Re: Town of Yorktown Tree Committee
Comments New York City Dept. Environmental Protection
DEP Log #: 2020-CNC-0078-SQ.2

Re: Teatown Lake Reservation Dredge Project
3-5554-00145/00011,12 (EF, FW, WQC) NOIA dated 12/21/2023

Teatown Lake Reservation is committed to protecting the environment as it's core mission and on behalf of my client I am pleased to be able to answer the questions and request for additional information in the Notice of Incomplete Application (NOIA) for the Joint Application that was submitted on 12 September 2023.

TEATOWN LAKE DREDGING

**GEOTUBE STOCKPILE
SITE NO. 2 PLAN**

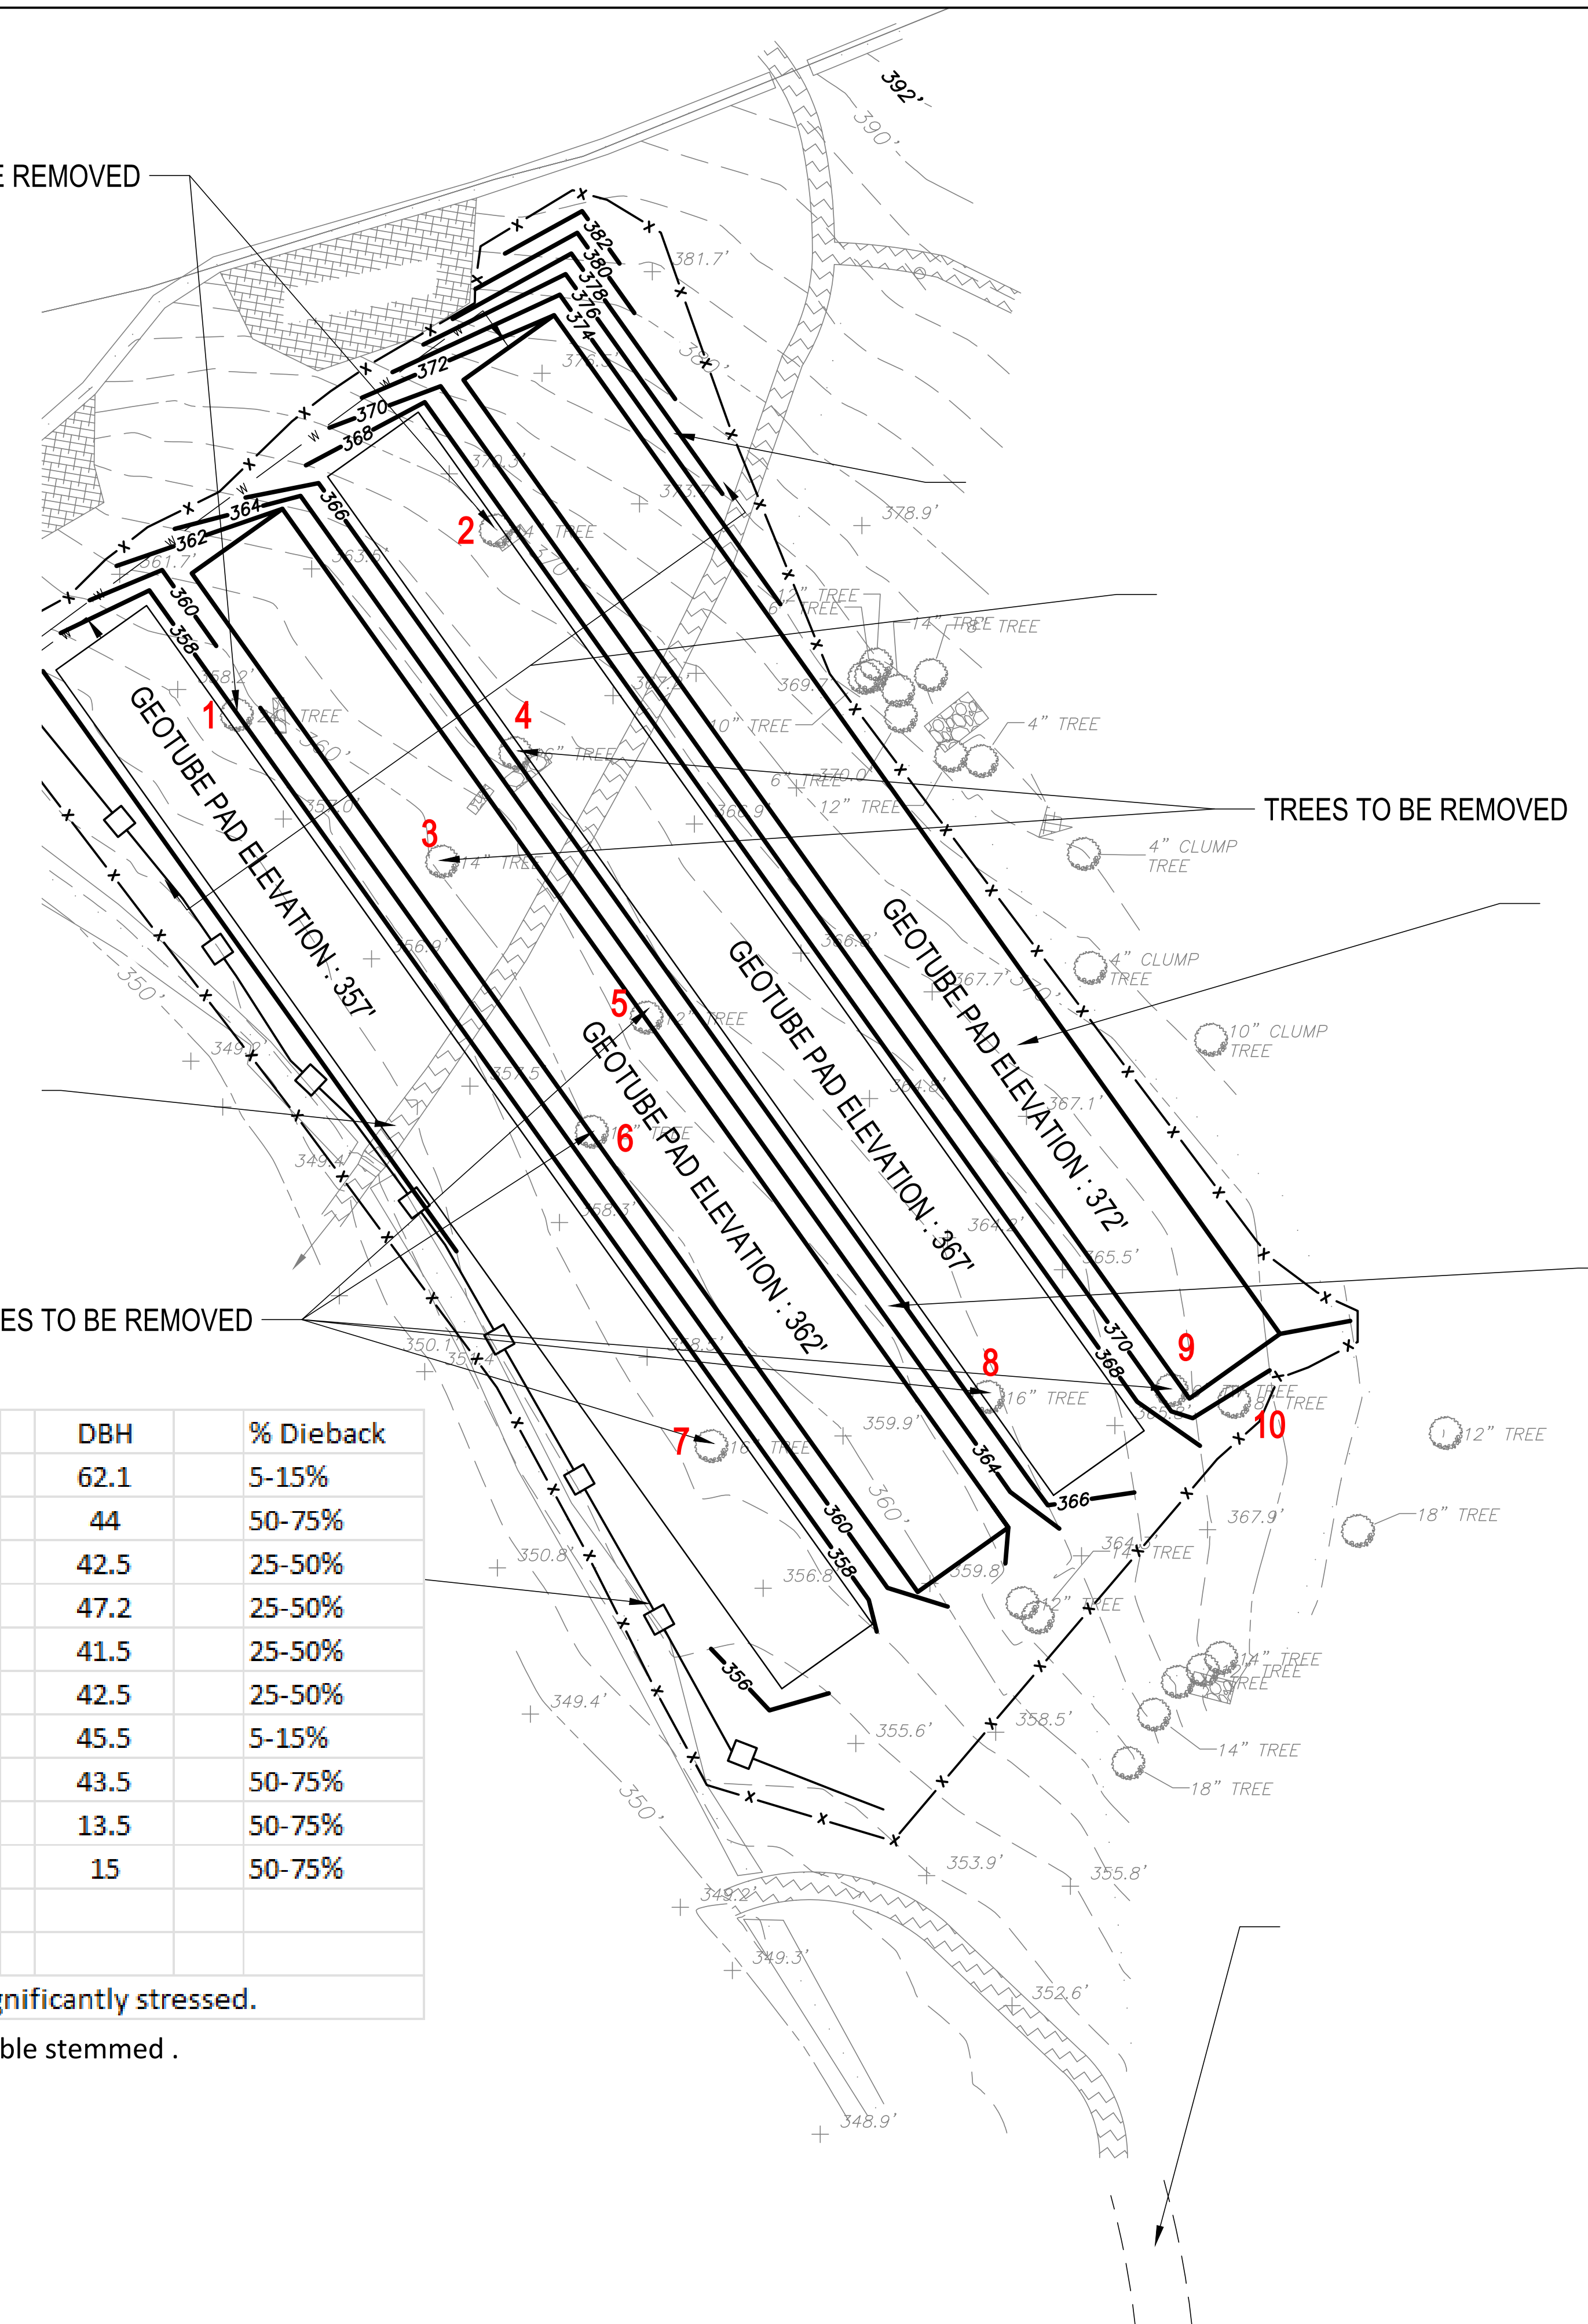
At the request of the Tree Commission Advisory Committee, I have also included a site plan for the Hidden Valley dewatering location that includes a table of the species and diameter breast height of the trees to be removed.
